ADDENDUM NO. 1 TO CONTRACT DOCUMENTS

Project: Poplar Tent Area Water Pump Station
City Project No. 2024-041
Hazen and Sawyer Project No. 32180-015

DATE: August 20, 2025

Owner: City of Concord

TRANSFORMER PAD
45 TO 2500 KVA

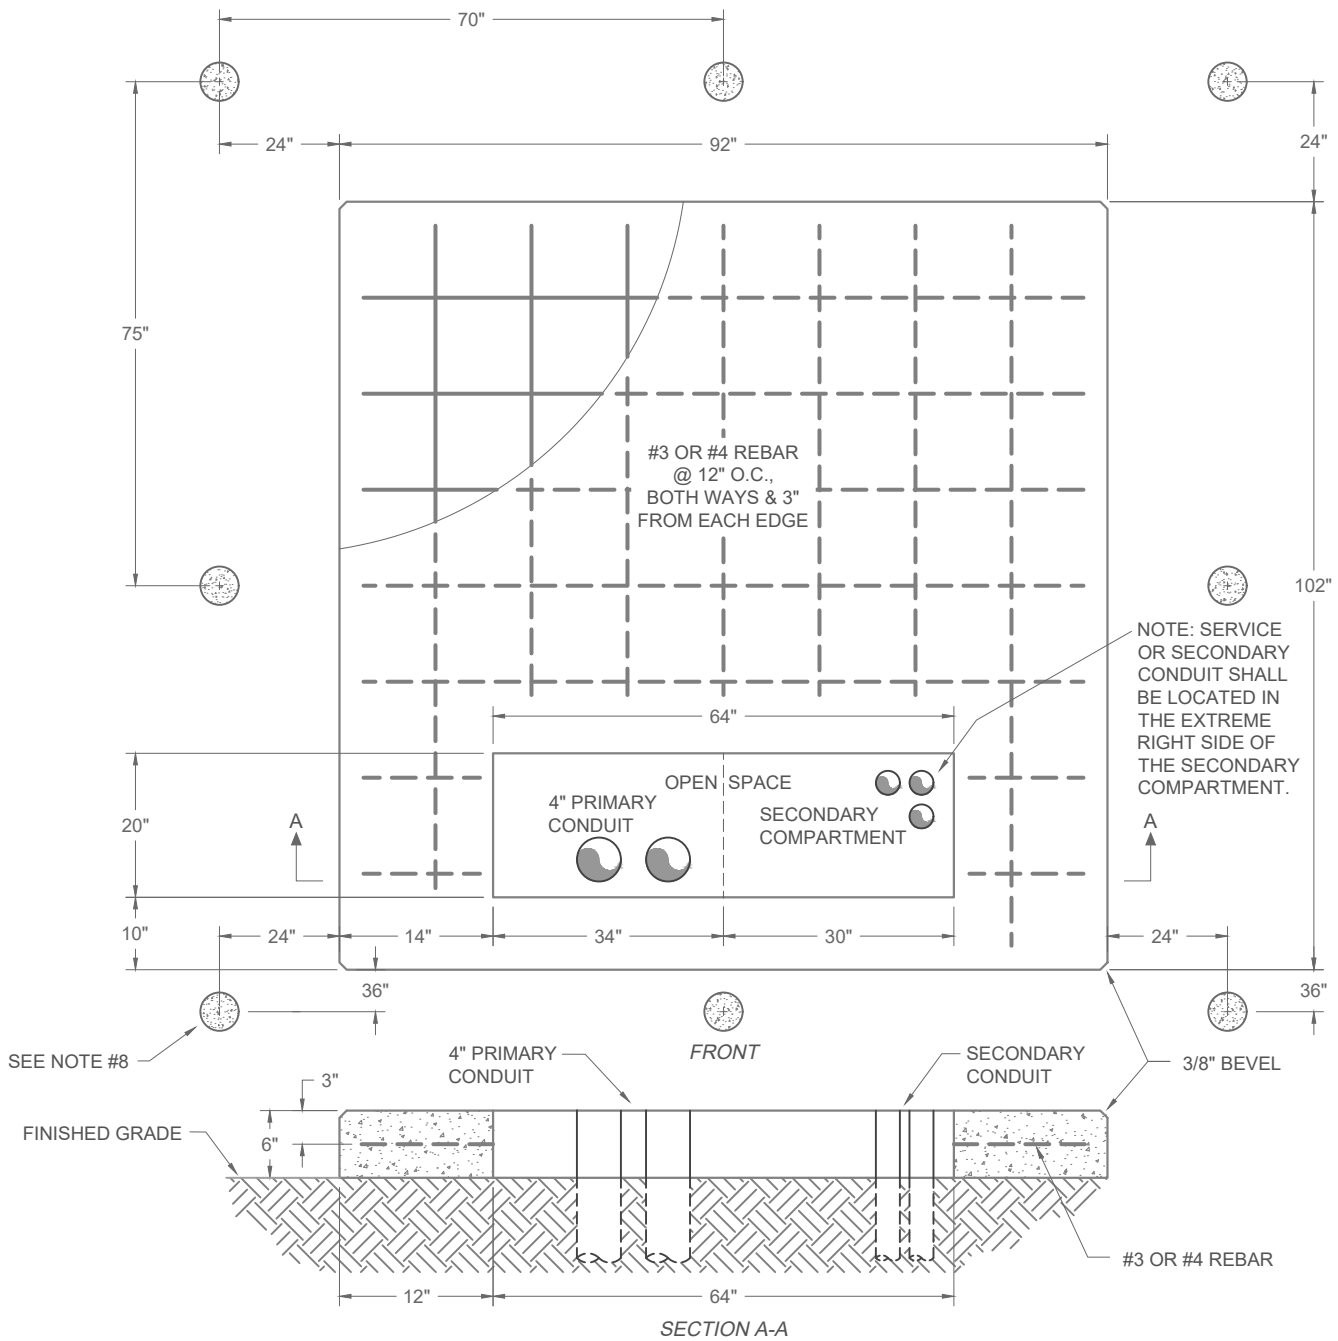
Revise the callout “6’X6’ PAD MOUNTED TRANSFORMER, SEE DETAIL S-03-0508” to the following:

“PAD MOUNTED TRANSFORMER, SEE NOTE 5.”

Add the following note:

“5. The Electric Utility will install the Owner-furnished transformer. The Contractor shall be responsible for constructing the transformer pad. The transformer pad shall be constructed in compliance with City of Concord Standard Detail ‘TRANSFORMER PAD 45 TO 2500 KVA’. Coordinate final pad location in the field with Engineer.”

1. TRANSFORMER PAD LOCATION SHALL BE WITHIN 10' FEET OF HARD SURFACE (GRAVEL, PAVEMENT, CONCRETE, ETC.) ACCESSIBLE BY AN ELECTRIC LINE TRUCK. THE CLEARANCE BETWEEN TRANSFORMER PAD AND ANY LANDSCAPING SHOULD BE MAINTAINED AT 3' MINIMUM FROM SIDES AND BACK, AND 10' MINIMUM FROM FRONT OF THE PAD/TRANSFORMER. CLEARANCE FROM BUILDING WALL SHALL BE MAINTAINED AT 3' MINIMUM FROM THE SIDES AND BACK OF THE TRANSFORMER AND 10' MINIMUM FROM THE FRONT OF THE PAD/TRANSFORMER. THE PAD/TRANSFORMER SHALL BE LOCATED 10' MINIMUM FROM ENTRY/EXIT DOORS AND MAINTAIN A 10' CLEARANCE FROM OUTDOOR SEATING AREAS.

2. SOIL UNDERNEATH PADS SHALL BE FREE OF ROOTS AND OTHER ORGANIC MATERIALS AND BE THOROUGHLY TAMPED TO PREVENT WASHING. EXERCISE CARE IN BACKFILLING AND GRADING AROUND PAD.

3. RECOMMENDATION: REINFORCE WITH #3 OR #4 REBAR ON A 12"x12" GRID TIED SECURELY 3" ABOVE BASE ON CLEAN CONCRETE OR BRICK SUPPORTS. END OF REBAR TO BE 3" FROM OUTSIDE EDGE OF PAD.

4. CONCRETE PAD SHALL BE 6" THICK. CONCRETE TO BE 5-1/2% AIR-ENTRAINED WITH A MINIMUM OF 28 DAY STRENGTH OF 5000 PSI.
5. TOP SURFACE TO BE LEVEL, SMOOTH AND BEVELED APPROXIMATELY 3/8".

6. SERVICE OR SECONDARY CONDUIT SHALL BE LOCATED IN THE EXTREME RIGHT SIDE OF THE SECONDARY COMPARTMENT.
7. SOME OLDER MODEL TRANSFORMERS MAY HAVE SMALLER COMPARTMENTS AND IT MAY BE NECESSARY TO GROUT A SMALL PORTION OF THE PAD OPENING.

8. IF LOCATED IN AN AREA SUBJECTED TO VEHICULAR TRAFFIC, THE TRANSFORMER SHALL BE PROTECTED ONLY ON SIDES EXPOSED TO VEHICLES BY POSTS AS SHOWN. MINIMUM 4" CONDUIT, CONCRETE FILLED, EMBEDDED 18" DEEP IN CONCRETE, EXTENDING 36" ABOVE FINISHED GRADE.

9. CONDUCTOR CONDUITS SHOULD BE FLUSH WITH TOP SURFACE OF PAD.
10. EXCEPTIONS TO THE ABOVE FOR UNUSUAL CONDITIONS MUST HAVE PRIOR APPROVAL FROM CITY OF CONCORD ELECTRIC SYSTEMS DEPARTMENT.
